APPLICATION NO.	FILING DATE	FIRST NAMED INVENTOR	ATTORNEY DOCKET NO.	CONFIRMATION NO.
09/705,996	11/03/2000	Yang Zhao	MEMSC-001XX	6364

Office Action Summary

DETAILED ACTION

Fig. 16

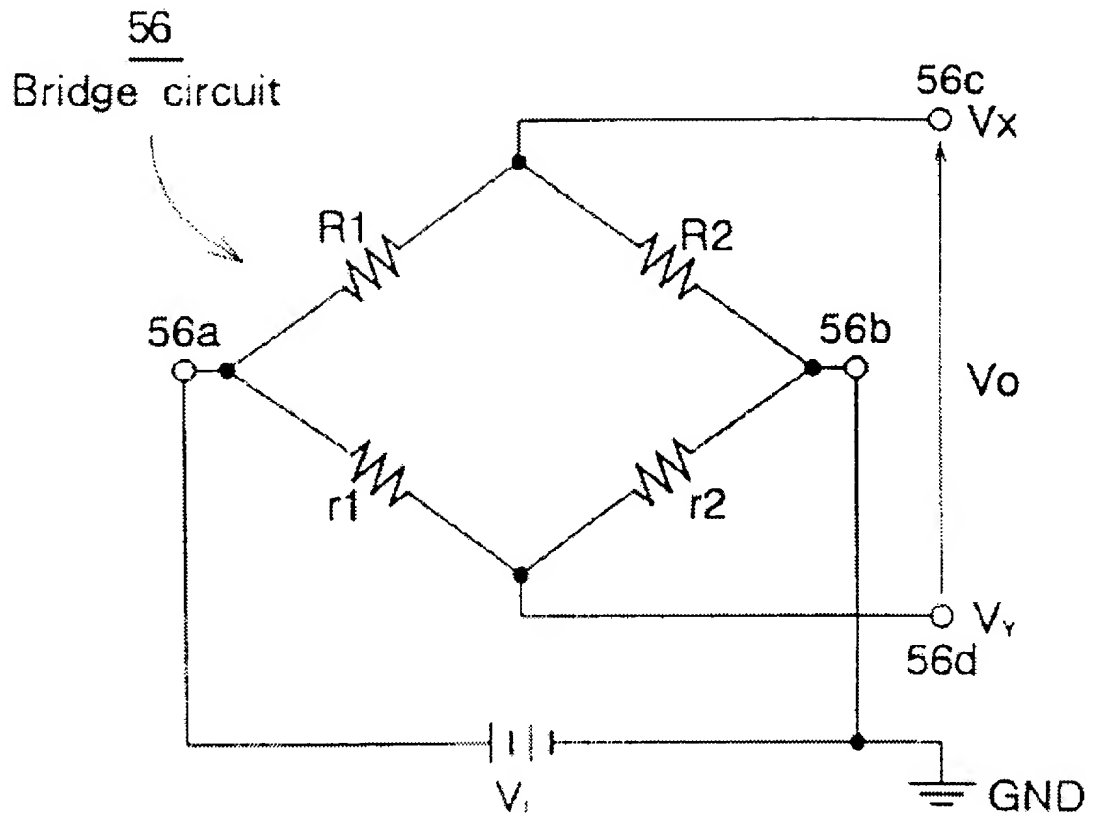
Referring to claim 8, Hosoi teaches the chip above, further including a reference voltage generator operative to generate a reference voltage level (Fig. 5, element 17, Col. 5, line 57 – Col. 6, line 14).

Referring to claim 9, Hosoi teaches the chip above, wherein the reference voltage level is a fixed voltage level (Fig. 5, element 17, conventional circuit element for a constant voltage source).

Referring to claim 10, Hosoi teaches the chip above, wherein the reference voltage level is proportional to a supply voltage level (Fig. 5, element 17).

Referring to claim 11, Hosoi teaches the chip above, wherein each temperature sensing element has a respective first terminal and a respective second terminal, wherein the respective second terminals of the temperature sensing elements are connected, wherein the acceleration sensor is operative to generate the differential output voltage across the respective first terminals of the temperature sensing elements (Figs. 5 and 16), and wherein the acceleration sensor is further operative to set the connected respective second terminals of the temperature sensing elements to a desired voltage level proportional to the reference voltage level (See Figs. 5 or 16, elements 56a and 56b).

FIG. 11

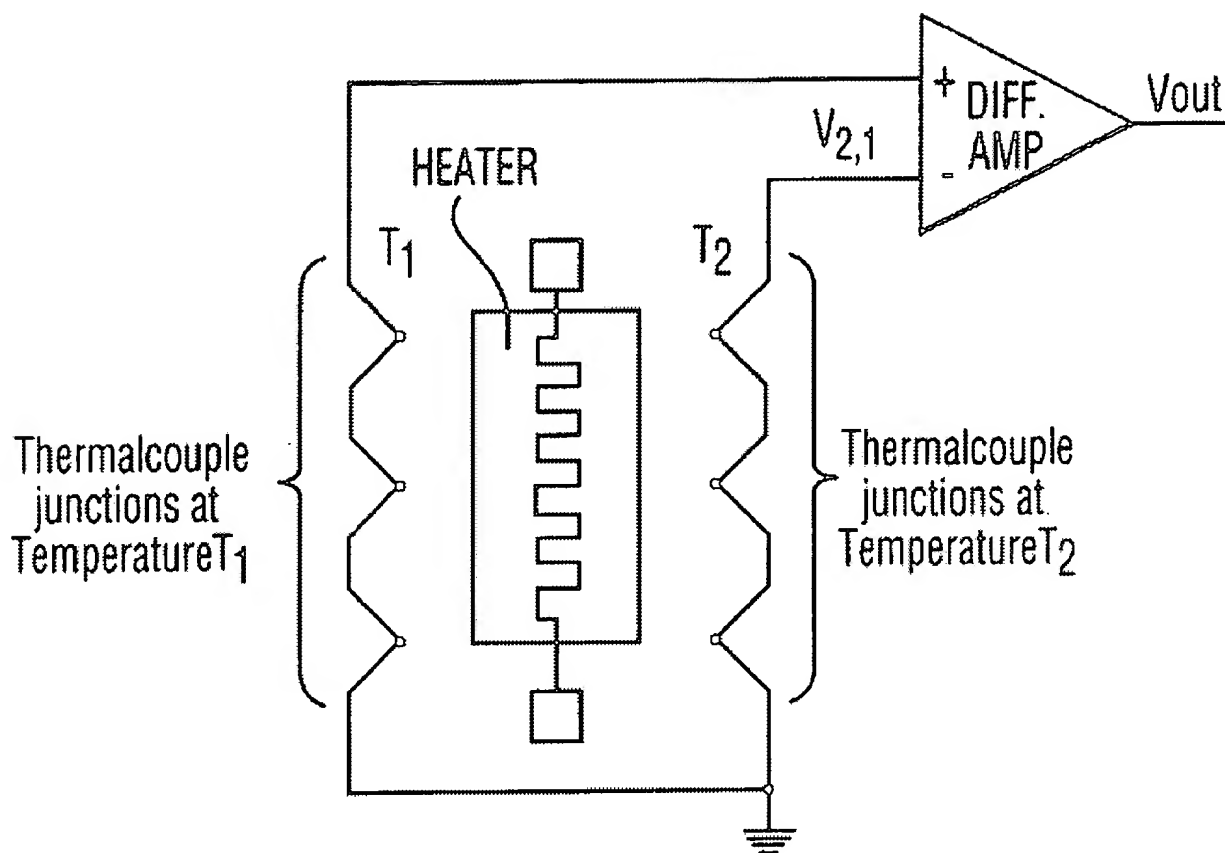
a convective acceleration sensor including a heater element and a plurality of temperature sensing elements (Abstract; Fig. 11), the plurality of temperature sensing elements being operative to generate a differential output voltage indicative of a magnitude of acceleration applied along at least one axis passing through the heater element and the plurality of temperature sensing elements (Col. 2, lines 29-30; Col. 9, claims 9 and 16; Col. 5, lines 13-27); Leung clearly teaches amplification circuitry configured to receive the differential output voltage generated by the plurality of temperature sensing elements (See Fig. 11 below).
